Rezoning Transportation Analysis

Petition Number: 2018-100

From: Felix Obregon, PE
fobregon@charlottenc.gov
704-432-5729

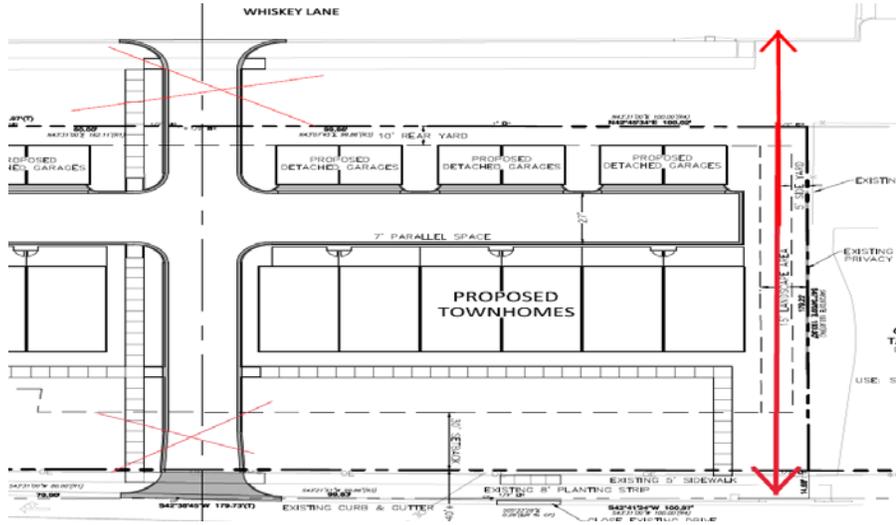
- Curbline** The proposed zoning district has a setback measured from back of the existing or proposed future curbline. The location of the future back of curb for providence is in its existing location. The location of the future back of curb for South Wendover Road is 8' behind the existing back of curb.
- Traffic Study** A Traffic Impact Study is not necessary for the complete review of this petition.

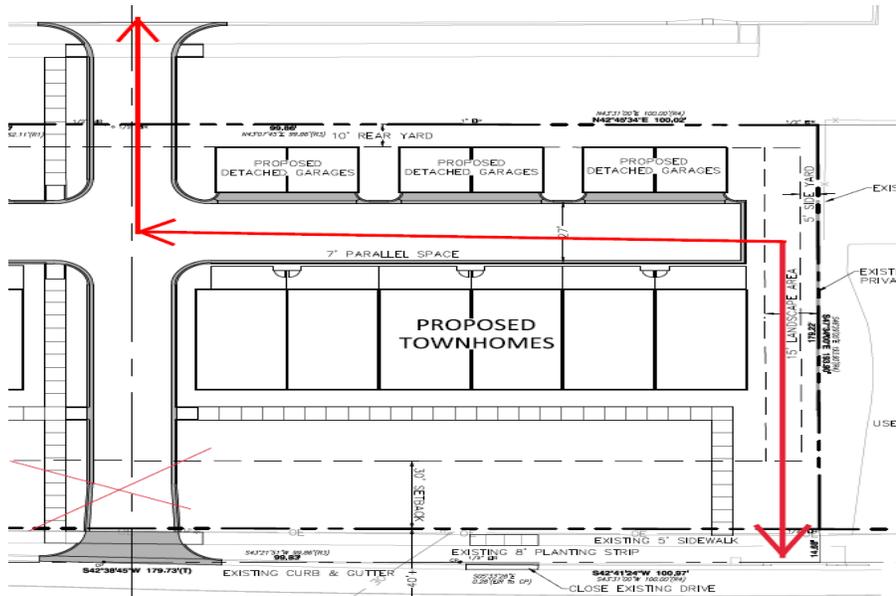
3. The petitioner should revise the site plan and conditional note(s) to install 16' planting strip and 6' sidewalk on South Wendover Road and Providence Road.
4. The petitioner should revise the site plan and conditional note(s) to relocate the access/street off of South Wendover Road to either of the following scenarios: **COMMENT RESCINDED: Petitioner removed access off of South Wendover Road.**

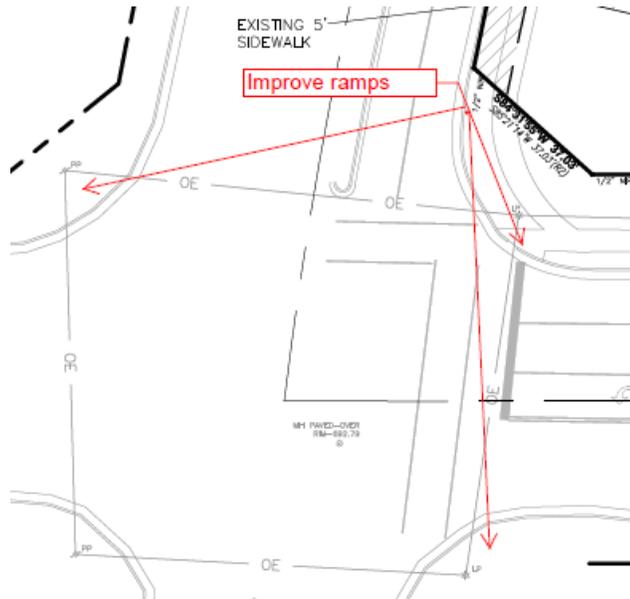
- The petitioner should revise the site plan and conditional note(s) to improve ramps at the intersection as shown below: **Clarification:** CDOT would like the petitioner to create two ramps on the corner adjacent to property as well as improving receiving ramps opposite site. The intent for UR-2 districts is to create a more intense environment, under 9.407 (1)(a)(i) the objective states to enhance and extend public amenities such as parks and public pedestrian ways.
